Subject: Technical Letter: Review of Polígono con Ampliación por Pistas 5 y 6

During MITRE's visit to Mexico City on 15-16 February 2017 to meet with officials from GACM and other stakeholders, the MITRE team received a paper copy of the drawing entitled "Polígono con Ampliación por Pistas 5 y 6", dated 8 April 2015. Note that MITRE previously received from Aeropuertos y Servicios Auxiliares (ASA) an electronic copy of the same drawing in AutoCAD in June 2015. Among other key data, the drawing depicts the official property boundary for the Nuevo Aeropuerto Internacional de la Ciudad de México (NAICM) and acquisition information regarding parcels of land within and adjacent to the NAICM site boundary.

Figure 1. Parcels Requiring Confirmation of Acquisition

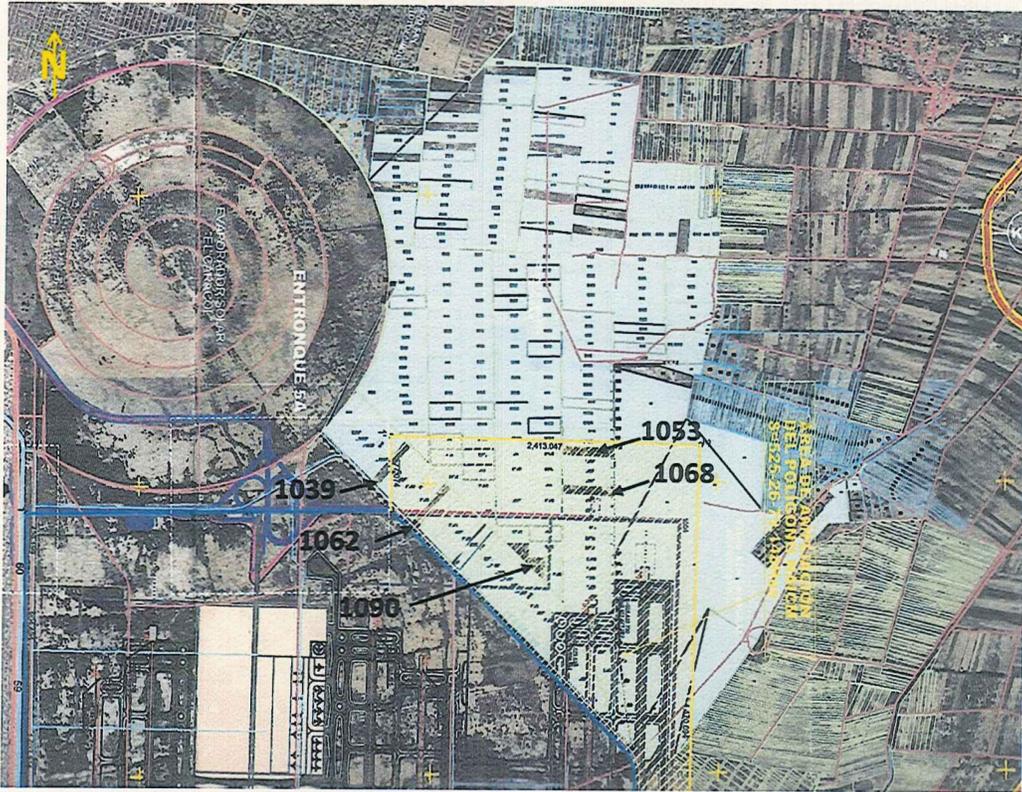
Figure 1 shows a scanned version of the paper drawing that was provided to MITRE. The yellow hatched area indicates the land to be used for accommodating Runway 5 and Runway 6. MITRE noticed that several parcels within and adjacent to the NAICM site boundary had yet to be acquired. Based on the symbology in the drawing, parcels 1039, 1062, 1090, 1053, and 1068, which are located within the yellow hatched area, have yet to be acquired. These parcels are in important areas in relation to Runway 5 and Runway 6. Parcels 1053 and 1068 are critical as they are located along the extended centerline of Runway 5. **Therefore, MITRE would like to receive confirmation that each of the five above-mentioned parcels have or have not been acquired.**

In closing, GACM should confirm the status of parcel acquisition as described above. Any parcels that have not been fully acquired should be acquired as soon as possible. **This can become a difficult problem if not taken care of.** MITRE requests to be informed when any remaining parcels are acquired. In addition, MITRE recommends that GACM updates their property boundary drawing to reflect the latest runway locations, as well as the latest status on parcel acquisition. Once updated, that drawing (preferably geo-referenced in AutoCAD) should be provided to MITRE.

Figure 2. Parcels and Areas Lacking Symbology

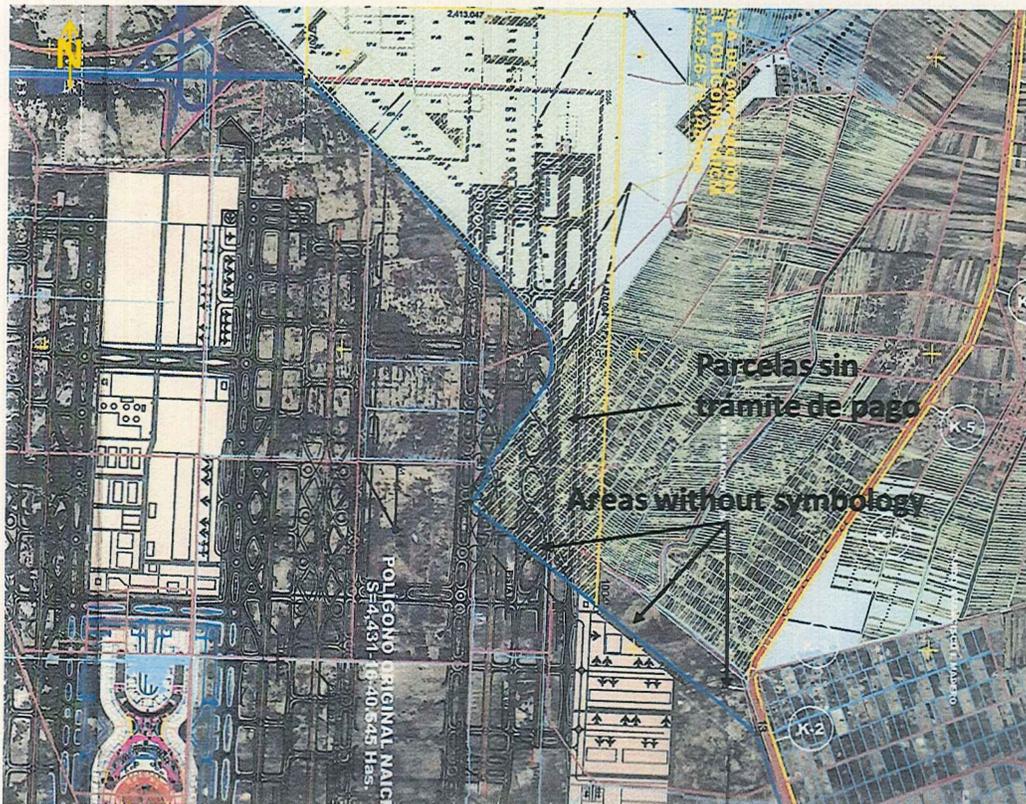
In addition, there are areas in the drawing, which are depicted in Figure 2 below, that lack any symbology or classification regarding their acquisition status or have been labeled as "parcelas sin trámite de pago." **It is important that MITRE understands if these areas and parcels have been acquired, or when they will be acquired.**

Figure 3. MITRE's Recommended Runway Configuration

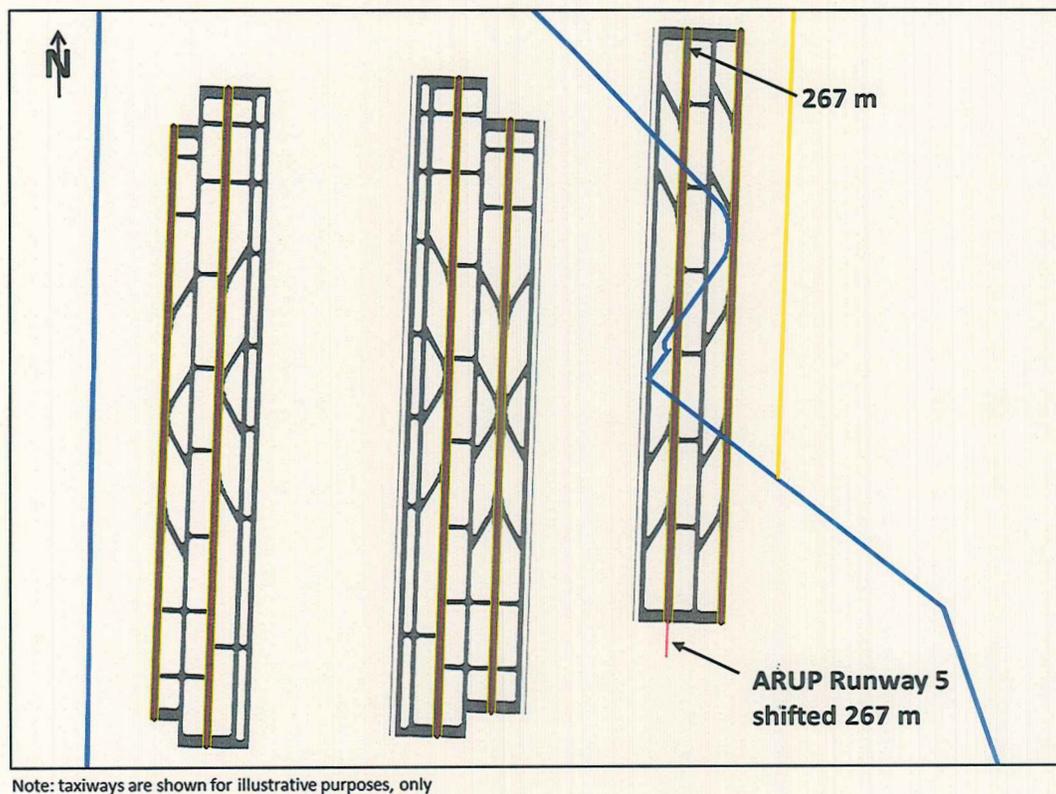
Another key observation about the drawing is that **it does not show the latest runway locations**. In June 2015, after the date that this drawing was produced, the previous Master Planner (i.e., ARUP) shifted the proposed runways at NAICM. Runways 1 and 2 (as counted from west to east) were shifted 10 m to the west and Runways 3, 4, 5, and 6 were shifted 10 m to the east, resulting in new runway threshold coordinates.

Additionally, there is a difference in the location of Runway 5 (which was proposed by the previous Master Planner) and MITRE's recommended runway configuration. Figure 3, below, shows MITRE's recommended runway configuration with a comparison of Runway 5 that was proposed by the previous Master Planner. It is important to note that MITRE has never examined the feasibility of the location of Runway 5 that was proposed by the previous Master Planner, which is shifted 267 m south of MITRE's Runway 5. Also, to be clear, MITRE is not indicating that the Runway 5 location should be the one in MITRE's recommended runway configuration. MITRE is only pointing out that the location proposed by a previous Master Planner was never examined by MITRE.

Figure 4. MITRE's Recommended Runway Configuration with ALSs

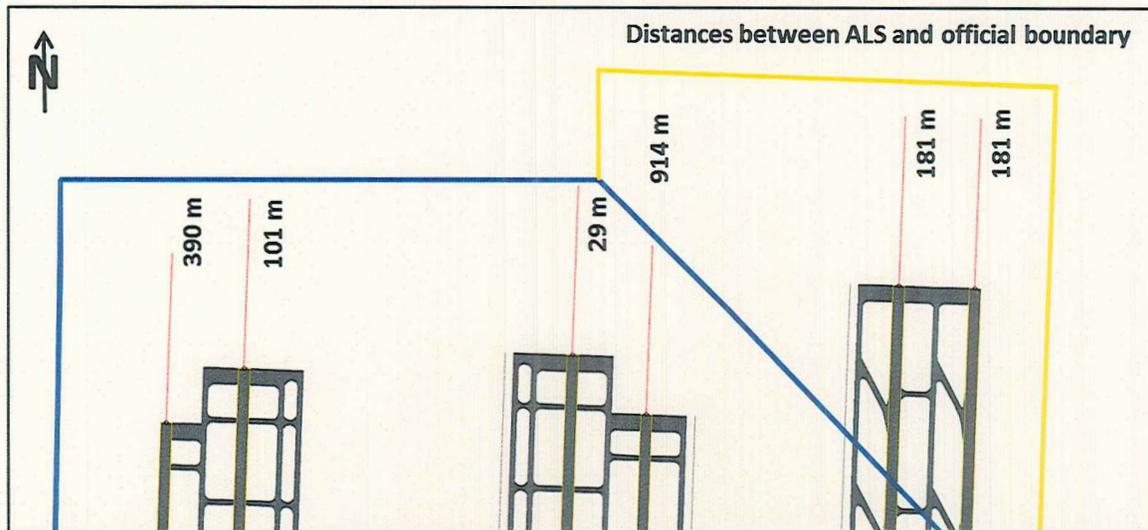
Using MITRE's recommended runway configuration, MITRE analyzed whether the official boundary at NAICM allows for sufficient space to locate the ALSs to the north of all runways. In doing so, an ALS with a length of 900 m from the physical end of each runway was assumed for planning purposes. Figure 4 shows the distances from all ALSs on the northern runway ends (shown in red) to the official boundary. It is important to note that all ALSs appear to be located within the NAICM official boundary, as depicted

in the figure below. The figure also shows the distance from the northern end of the ALSs to the NAICM official boundary.
